STATE OF ILLINOIS  
DEPARTMENT OF TRANSPORTATION

VARIOUS LOCATIONS  
SUMMARY OF QUANTITIES

F.A. RTE.	SECTION	COUNTY	TOTAL SHEETS	SHEET NO.
VAR.	2021-055-DR	VARIOUS	125	4
			CONTRACT NO. 62N86	
ILLINOIS FED. AID PROJECT

**175TH STREET – WESTERN AVE TO DIXMOOR DR  
TYPICAL SECTIONS**

**175TH STREET CROSS SECTIONS**

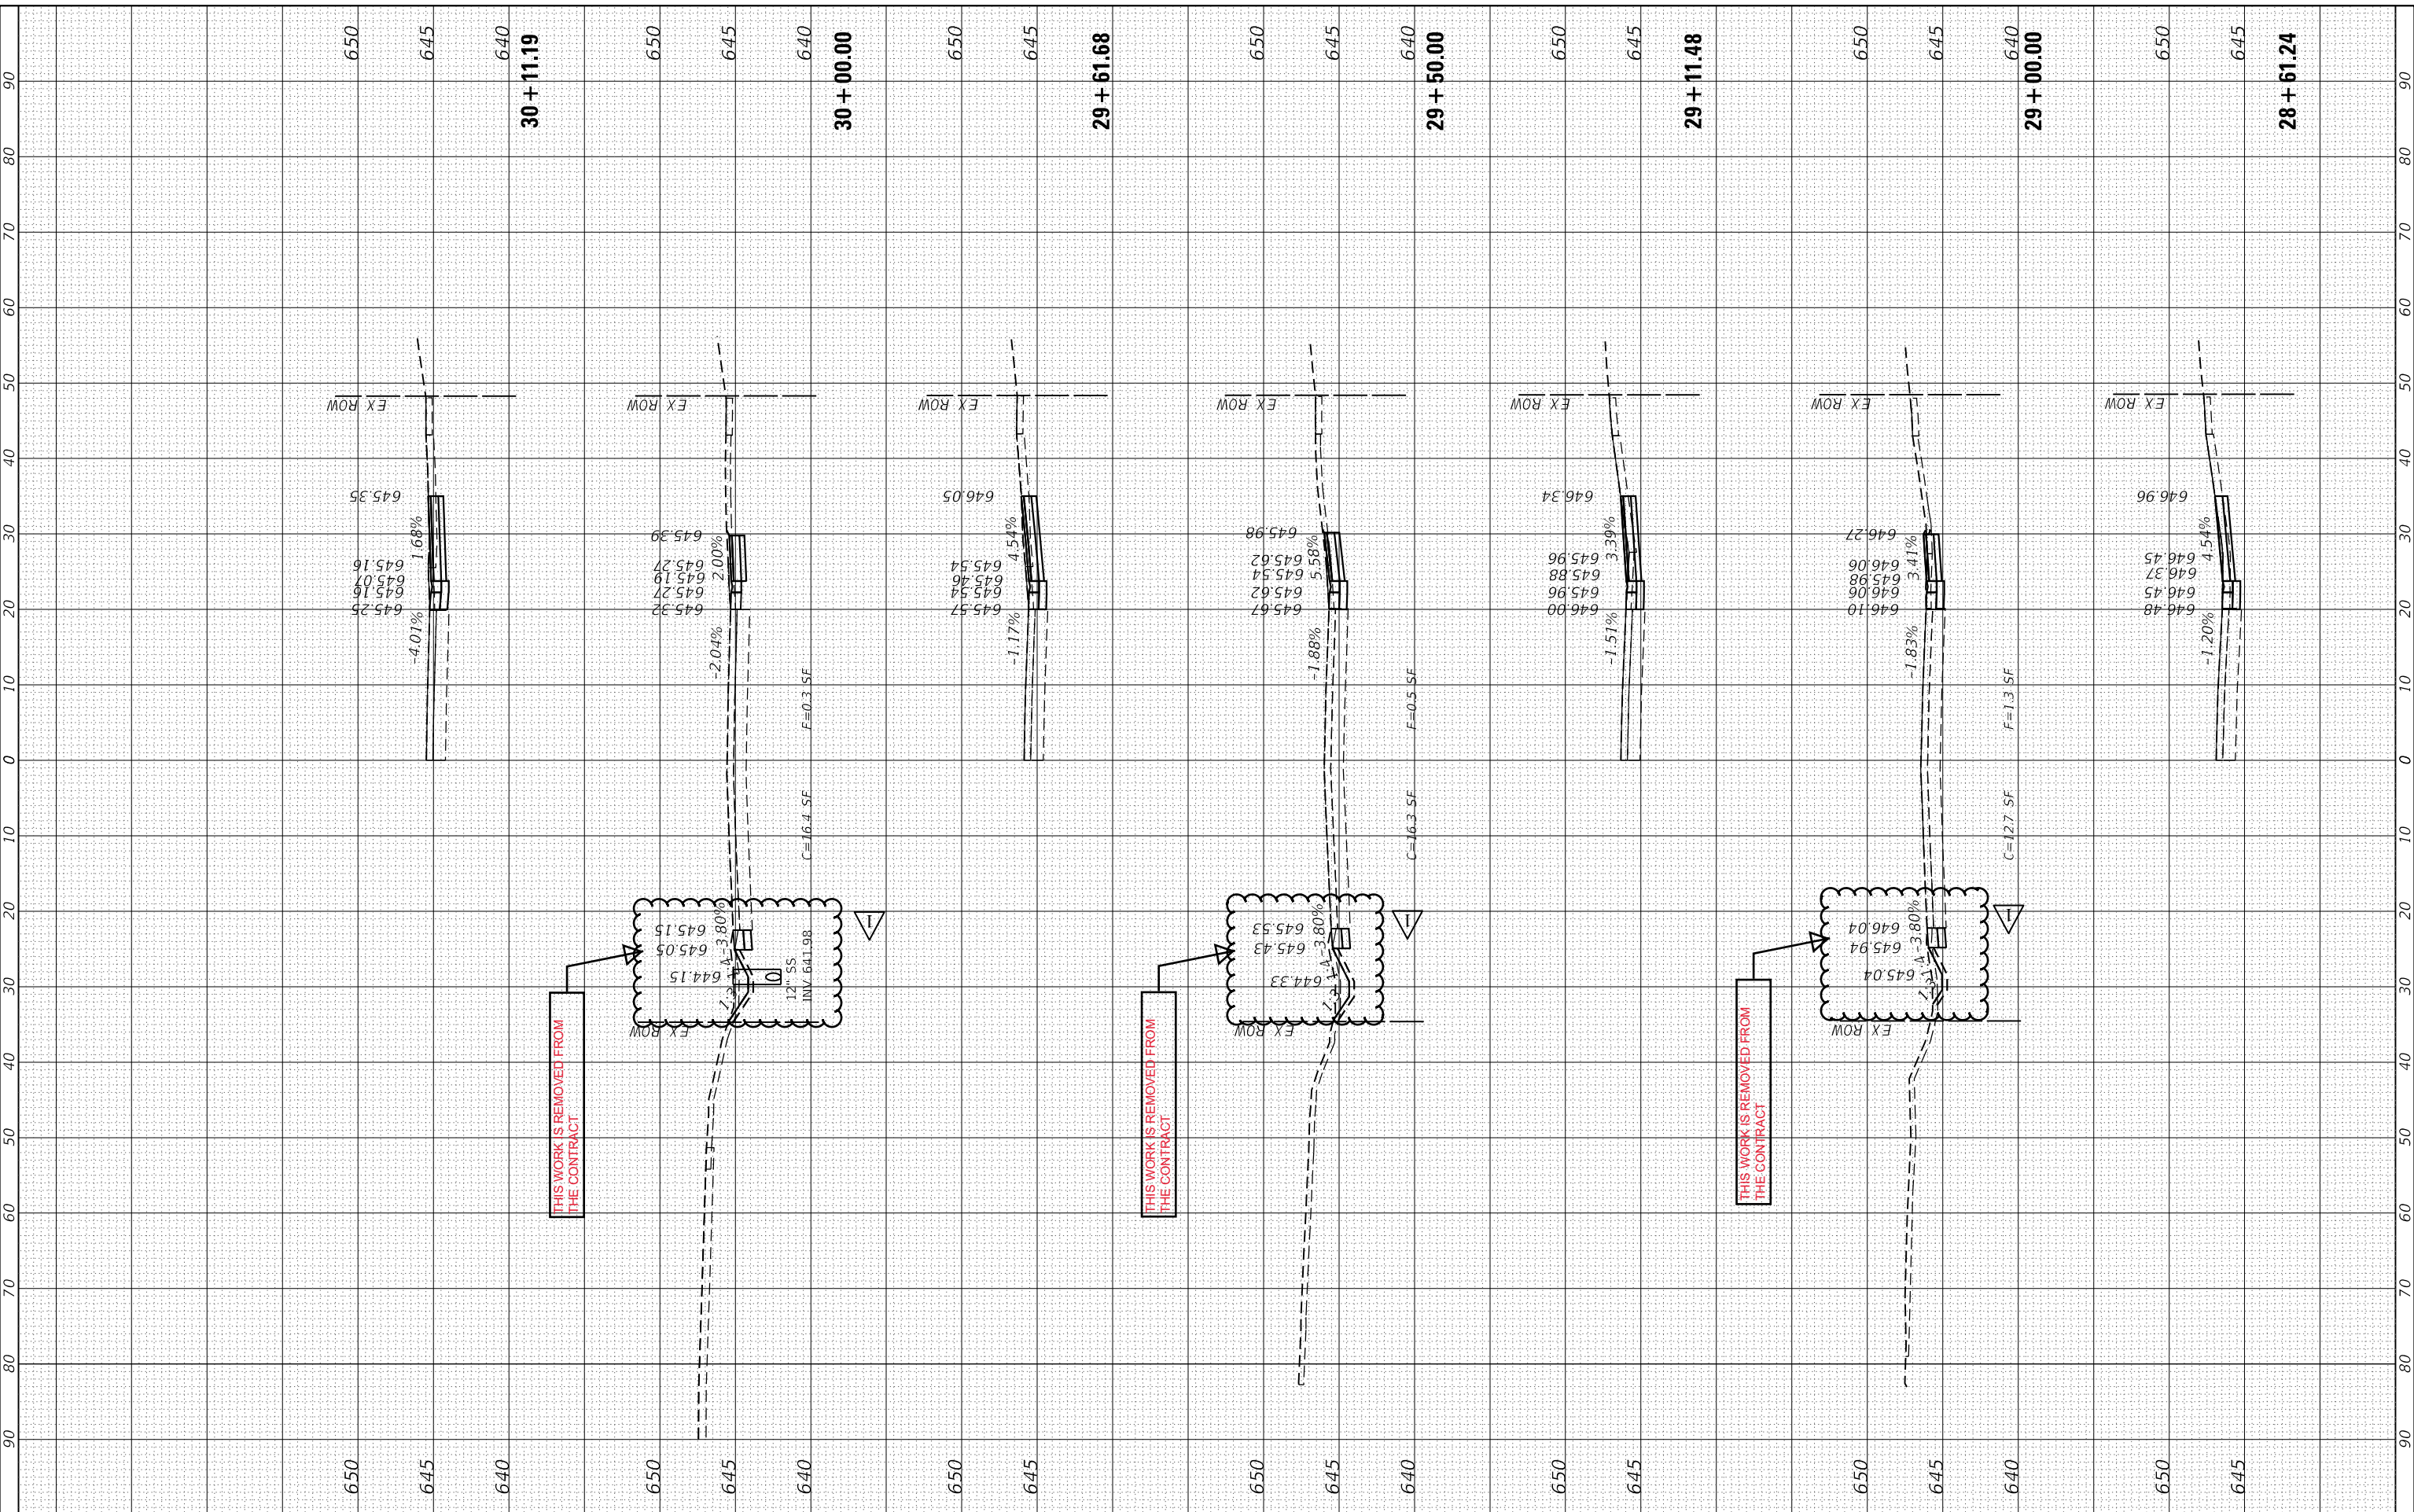
THIS WORK IS REMOVED FROM THE CONTRACT

THIS WORK IS REMOVED FROM THE CONTRACT

THIS WORK IS REMOVED FROM THE CONTRACT
